**DRAFT DESIGN REPORT**  
*FOR*  
**BURKE CREEK HIGHWAY 50 CROSSING AND  
REALIGNMENT PROJECT, PHASE I**  
*STATELINE, NEVADA*

**March 2016**

<b>Comments on Burke Creek HWY 50 Crossing and Realignment Project</b>				
			<b>Commenter: Erik Nilssen P.E., Douglas County</b>	<b>Responder: NTC Engineering</b>
<b>Comment #</b>	<b>Document</b>	<b>Page</b>	<b>Comment</b>	<b>Response</b>
DC-1	50% Plans	ii	Douglas County will need a set of as-built plans as well.	Noted
DC-2	50% Plans	ii	Note seems like it does not apply. Plenty of work will take place outside of the NDOT ROW.	Irrelevant portion of note has been deleted
DC-3	50% Plans	G-1	"Potential Access to Upstream Work Via Existing Sierra Colina Road" needs to be clarified. Is this an access or not? Contractor needs to know for sure what they can use.	The access point from the Douglas County ball fields has been made the primary access point for upstream improvements on the 90% plans. For separate Sierra Colina mitigation work, the Contractor may choose to use the Sierra Colina access point.

DESIGNED/DRAWN	MBG/MBG
CHECKED	MCK
DATE	06/24/2015
SCALE	AS SHOWN
PROJECT	BCC
SHEET	CD-2
	14 OF 19

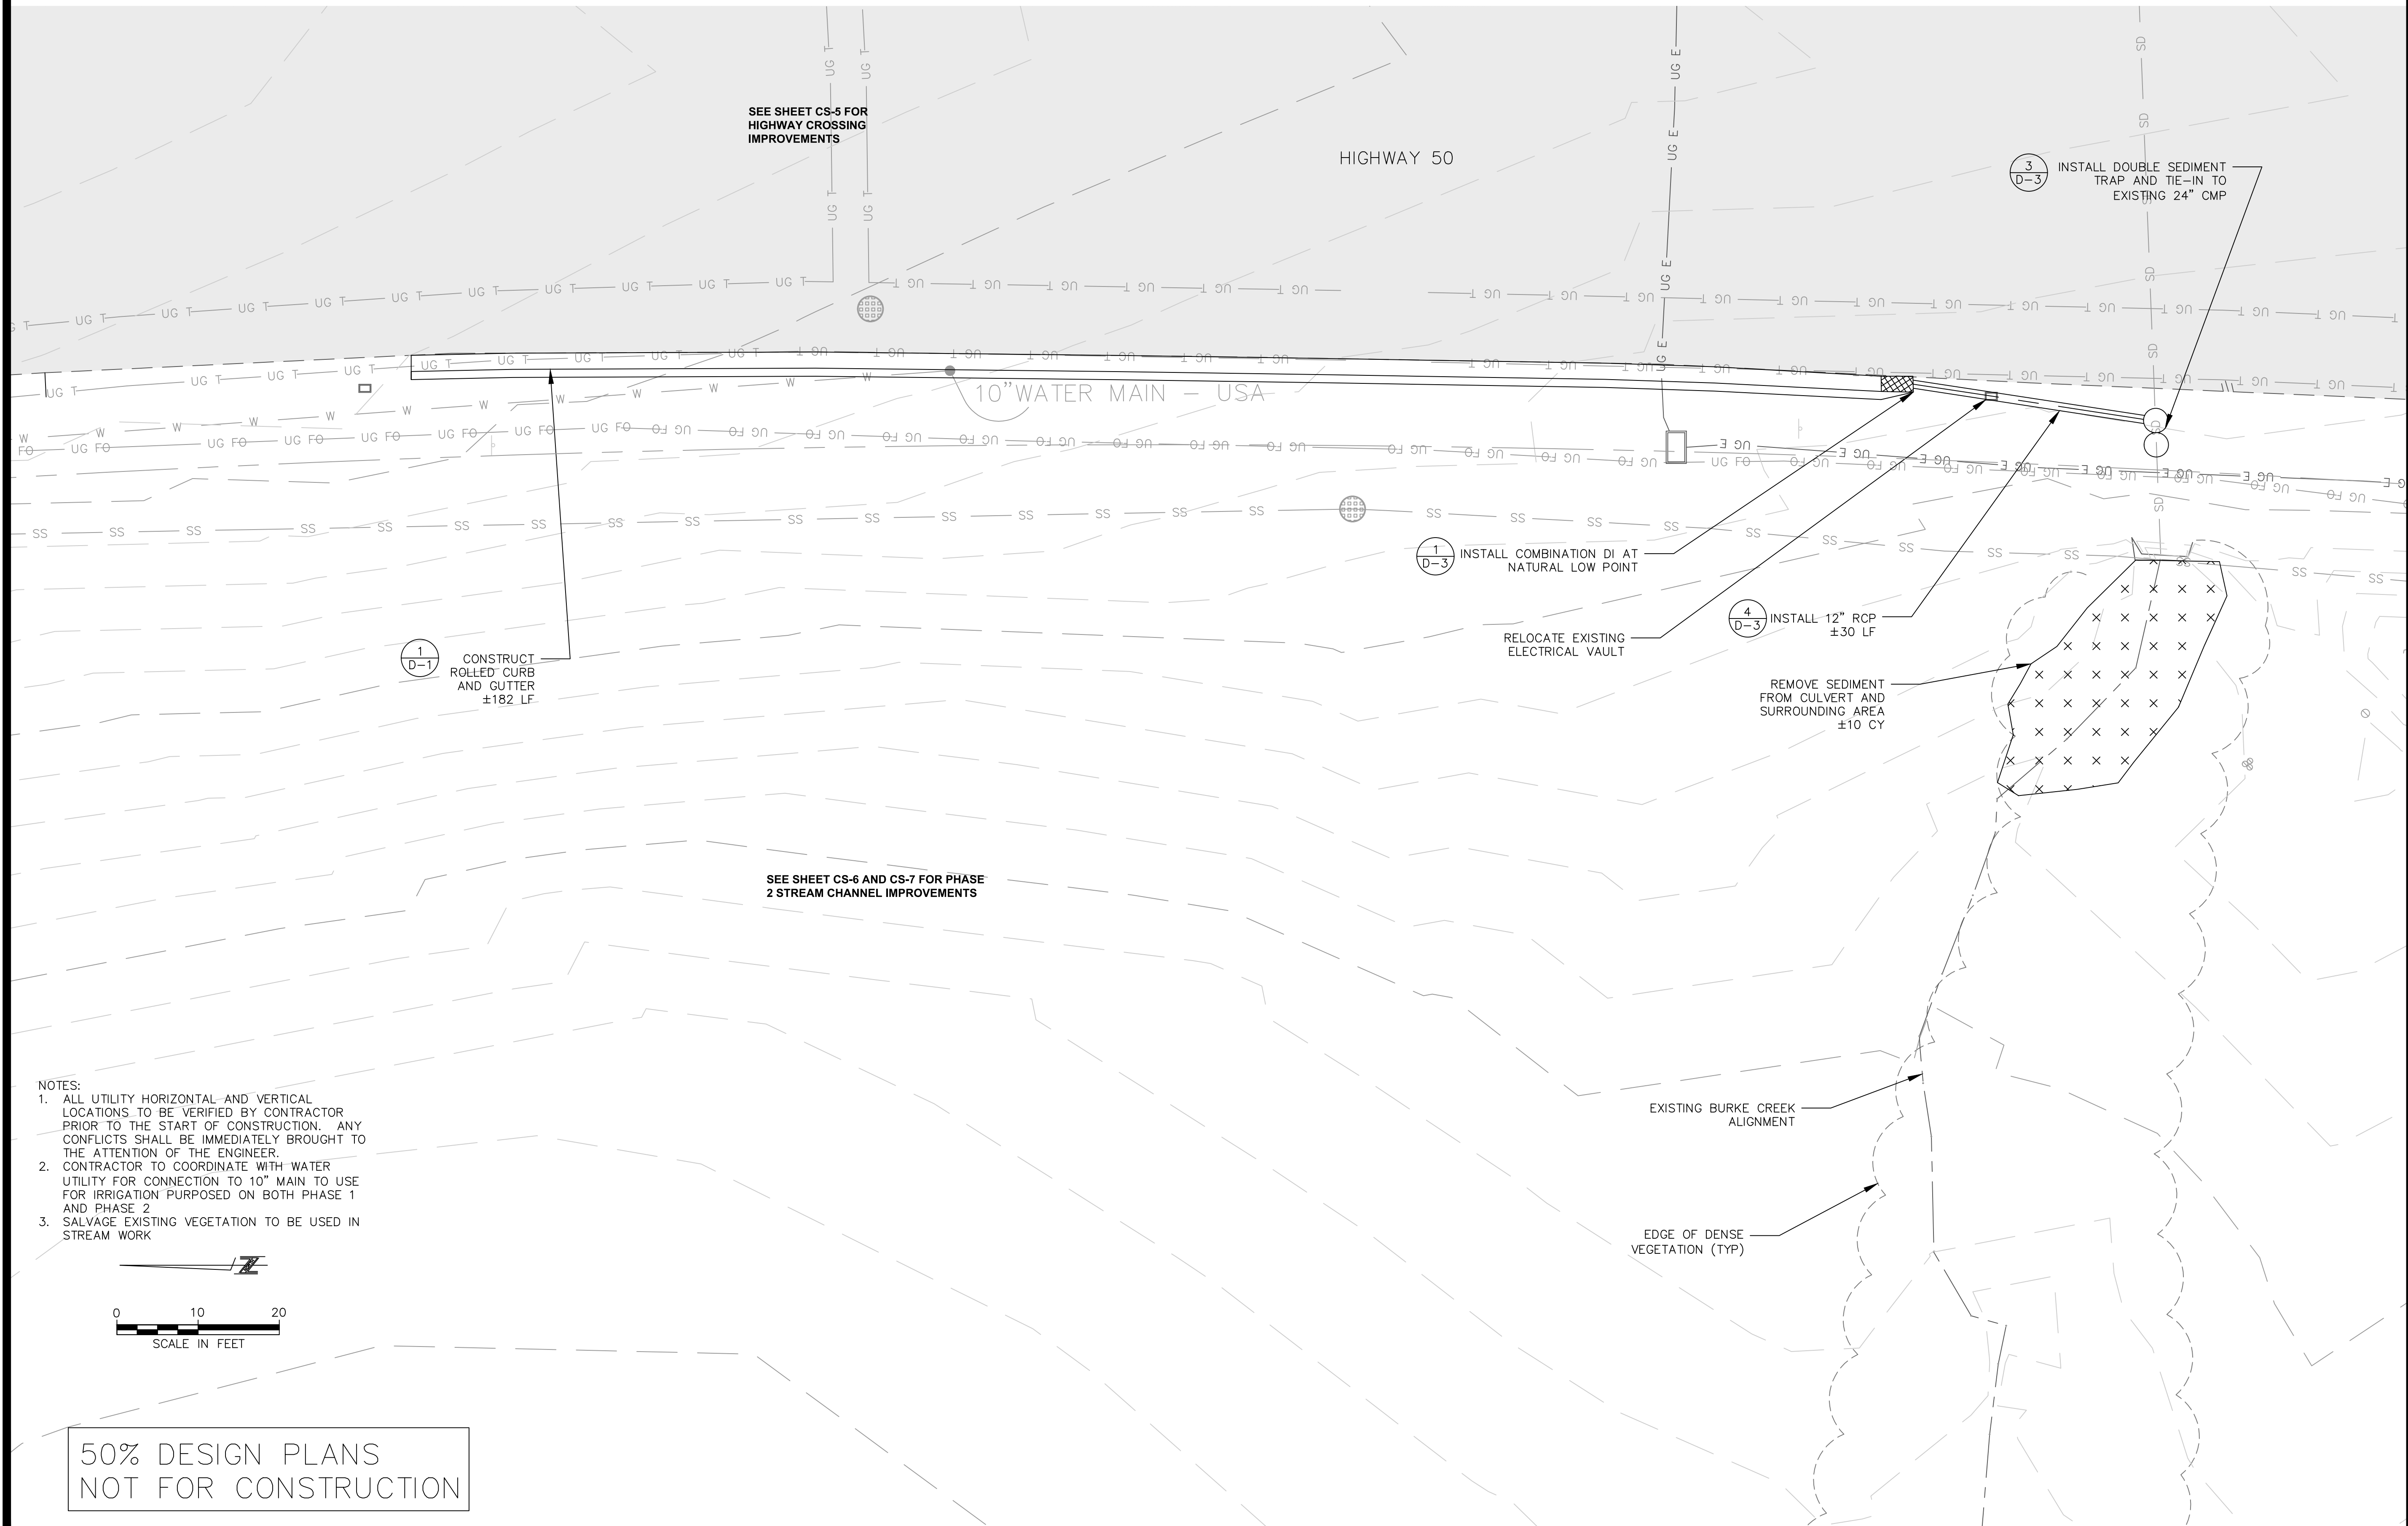
DC-24	50% Plans	CD-2	Note "Construct Vertical Curb" need detail.	Detail included with 90% design.
DC-25	50% Plans	CD-2	Note "construct A/C pavement in place of existing island" why are we removing this island? Seems they would like to have some landscaping. Not sure where TRPA is, but Douglas County requires landscape fingers every 8 parking spaces.	This improvement was eliminated from the design.
DC-26	50% Plans	CD-2	Why the callout to relocate the underground telephone lines? Seems like an unnecessary expense. Can't they leave them where they are?	Proposed grading will expose part of the telephone line. Also, the line would be completely inaccessible under the project flood control berm. Frontier Communications has expressed a desire to keep the lines accessible for maintenance.
